# ***Interactive comment on “Using global reanalysis data to quantify and correct airflow distortion bias in shipborne wind speed measurements” by Sebastian Landwehr et al.***

## **Response to Referee #1**

**Fig. 1.** Wind speed ratio as function of the relative wind direction. The marker colour denotes the absolute time difference to the 35 events, when data from UBXH3 was assimilated.

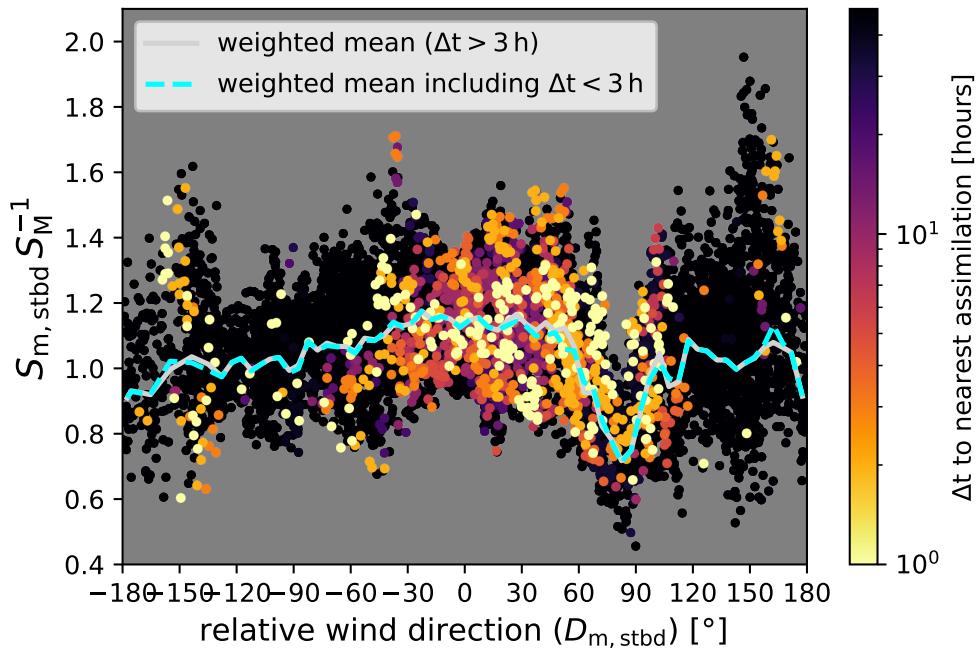
**RC 2:** *Introduction, 5th paragraph: The authors introduce reanalyses and note the assimilation of buoys and satellite data, but neglect the fact that ship data are also assimilated to most of these models. Were any data from the ACE cruise assimilated to ERA-5? I would expect if they were, they would have been from the standard hourly bridge reports that would be contributed to the Voluntary Observing Ship scheme.*

**AR 2:** Indeed wind speed observations from ships are still used in the data assimilation for ECMWF weather forecast model. In order to acknowledge this fact, we have added ships in the list of the in situ observations in page 3 line 3. The *Akademik Tryoshnikov* reported daily telegrams to the Arctic and Antarctic Research Institute (AARI). Following the request of the Scientific Committee on Antarctic Research (SCAR) and the World Meteorological Organisation (WMO), the observations were also reported to Global Telecommunication System (GTS) under the call sign UBXH3. ECMWF provided us with a list of the times and locations for which ground wind observations from UBXH3 were assimilated into the Integrated Forecast System (IFS) between November 2016 and April 2017 (see supplement information). The list contains 35 entries exclusively from leg 2, when the ship was south of 60°S. The data from intervals close to these time stamps cluster around ratio of  $S_m S_M^{-1} \approx 1$ , however, with considerable scatter (see Figure 1 that is attached to this reply). To avoid any feedback in the bias correction, we now excluded all observations that were within 3 hours before or after time stamps of the 35 assimilated observations. This leads to an additional removal of 1197 and 1216 five-minute samples for the port and starboard sensors, but has
